Project	IEEE 802.16 Broadband Wireless Access Working Group < http://ieee802.org/16 >	
Title	Multiple Broadcast Maps for OFDMA PHY	
Date Submitted	2004-11-13	
Source(s)	Ran Yaniv, Tal Kaitz, Vladimir Yanover, Naftali Chayat	ran.yaniv@alvarion.com
	Alvarion Ltd.	tal.kaitz@alvarion.com
	Yuval Lomnitz	yuval.lomnitz@intel.com
	Intel	
	Dave Pechner, Todd Chauvin, Doug C. Dahlby	dpechner@arraycomm.com
	Arraycomm	chauvin@arraycomm.com
		dahlby@arraycomm.com
Re:	Call for contributions, IEEE P802.16e/D5 Sponsor Ballot	
Abstract		
Purpose		
Notice	This document has been prepared to assist IEEE 802.16. It is offered as a basis for discussion and is not binding on the contributing individual(s) or organization(s). The material in this document is subject to change in form and content after further study. The contributor(s) reserve(s) the right to add, amend or withdraw material contained herein.	
Release	The contributor grants a free, irrevocable license to the IEEE to incorporate material contained in this contribution, and any modifications thereof, in the creation of an IEEE Standards publication; to copyright in the IEEE's name any IEEE Standards publication even though it may include port

Figure 229a – Illustration of DL sub-frame structure with multiple broadcast maps

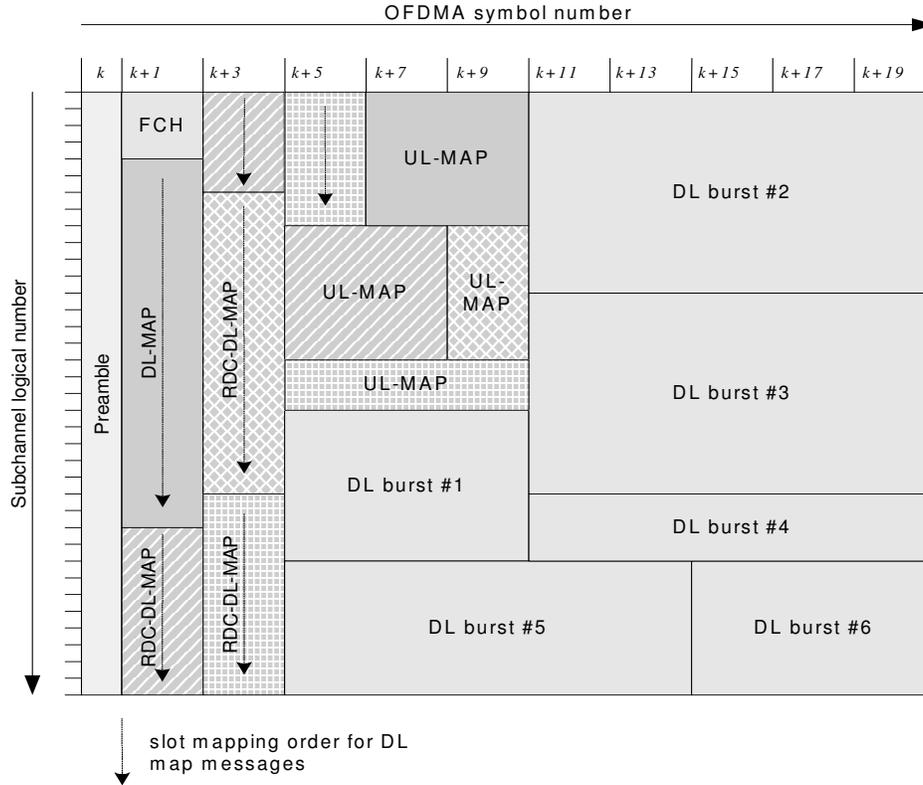
The number of RDC-DL-MAPs in a frame shall not exceed 3. The structure of the DL sub-frame with multiple broadcast maps is illustrated in figure 229a.

The BS may allocate dedicated PHY bursts, each containing a single RDC-DL-MAP message, for transmitting additional DL-MAP IEs with different burst profiles to SSs that support multiple broadcast maps. Such bursts, if exist, shall be allocated consecutively using the same uni-dimensional frequency-first slot mapping order used for the DL-MAP burst. The first burst containing an RDC-DL-MAP message shall be allocated starting at the slot immediately following the DL-MAP. Each RDC-DL-MAP message may also describe an RDC-UL-MAP message. The UL-MAP and RDC-UL-MAP messages shall each be processed independently.

The bursts containing the RDC-DL-MAP messages shall only be described by an RDC-DL-MAP-LIST IE. This IE (if exists) shall be the first IE in the mandatory DL-MAP message. An SS supporting multiple broadcast maps shall attempt to decode all PHY bursts containing RDC-DL-MAP messages.
